SUBJECT: Forwards response to Questions 1,2,3,4,7,9,10,12 & 13, based on questions raised during NRC review of 830624 submittal on proposed spent fuel pool expansion. Response to remaining questions will be provided by 831118.

Re: Nine Mile Point Unit 1
Docket No. 50-220
-----DPR-63-----

AUXILIARY SYSTEMS BRANCH
REQUEST FOR ADDITIONAL INFORMATION
NINE MILE POINT UNIT 1
SPENT FUEL POOL EXPANSION
DOCKET 50-220

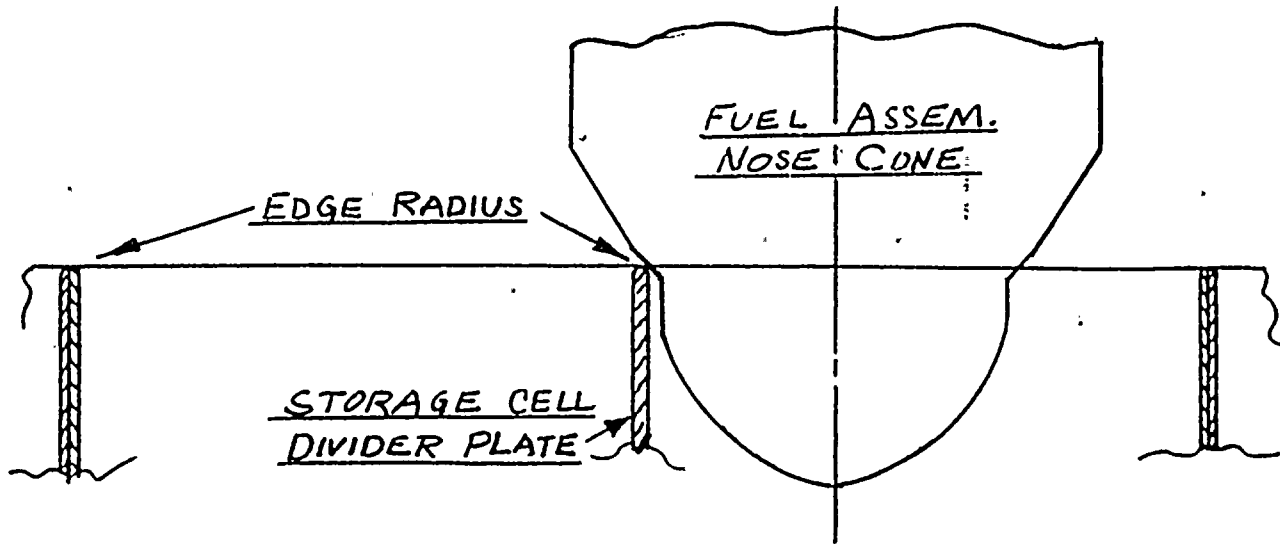
With the aid of drawings, describe the flow path of pool water into those storage cells directly above the rack pedestal shown in Figure 3 and demonstrate that the flow rate is such that sufficient margin exists between the temperature of the water exiting at the top of the fuel cell and the corresponding saturation temperatures.

As illustrated in Figure 1 attached, for storage cells located directly above the rack pedestals, cooling water will flow through (1) the four - 2.75 inch diameter flow holes (flow area = 23.76 square inches) in the pedestal side plates, (2) through the two - 4.0 inch diameter flow holes (flow area = 25.13 square inches) in the pedestal upper plate, and (3) into the fuel bundles through the two - 3.81 inch diameter flow holes (flow area = 22.80 square inches) in the bottom plate of the racks. For storage cells not located directly above the rack pedestals, the cooling water will flow into the fuel bundles through the two 3.81 inch diameter flow holes (flow area = 22.80 square inches) in the rack's bottom plates. Thus, the minimum flow area provided for cooling water flow to the storage cells located directly above the rack pedestals is the same as the minimum flow area provided for cooling water flow to other storage cells.

The maximum exit temperature of the water leaving the storage cells located directly above the rack pedestals will be the same as the maximum exit temperature of the water leaving other storage cells. Exit water temperature margins are indicated in the response to Question 3 of this response.

FIGURE 2

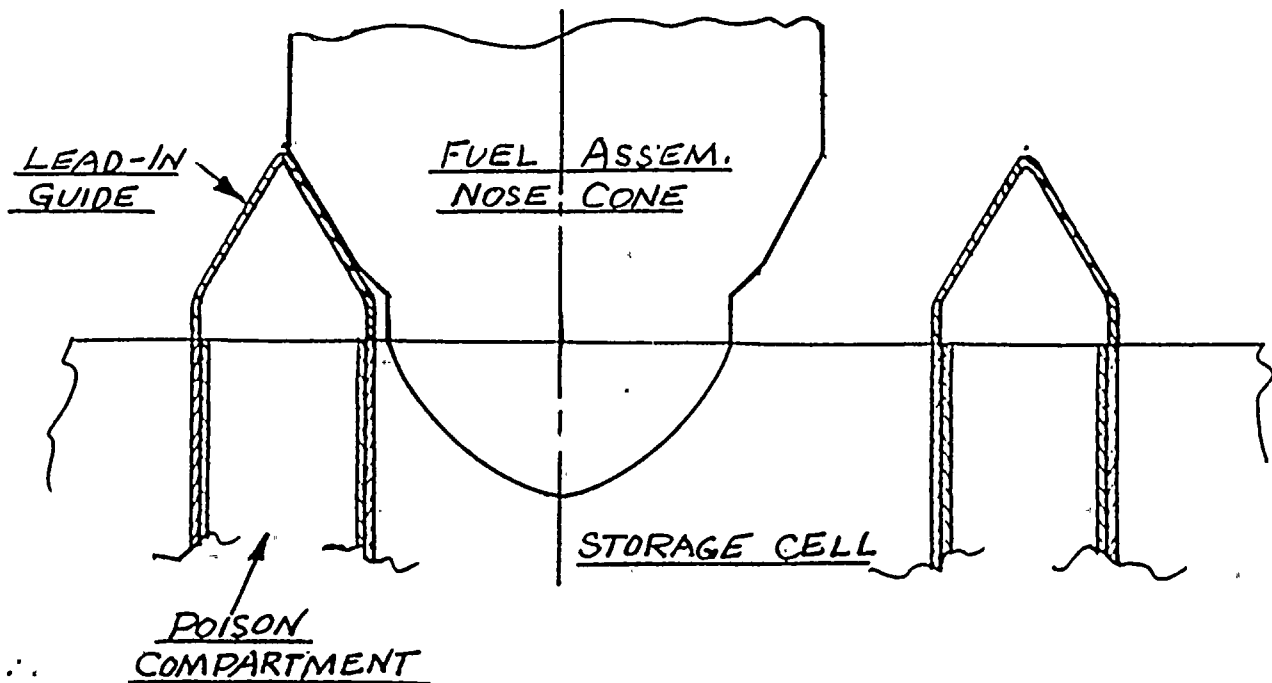
With the aid of drawings showing the dimensions of the fuel cell, describe and demonstrate that the lead-in provisions at the top of the cell provide adequate guidance for the insertion of fuel assemblies and for the fuel grappling device during the removal of fuel assemblies.

The channeled fuel assembly is 5.438 inches square. The nominal storage cell is 5.87 inches square providing .43 inch clearance. As illustrated on Figure 2 attached, the lead-in provided by the fuel bundle nose cone is used for fuel installation in the North-South direction where there are no lead-in guides. There are, however, lead-in guides in the East-West direction, as illustrated in Figure 2 attached. Figure 3 attached, shows that there is no problem with the fuel grappling device since the fuel handle is above the top of the storage racks.
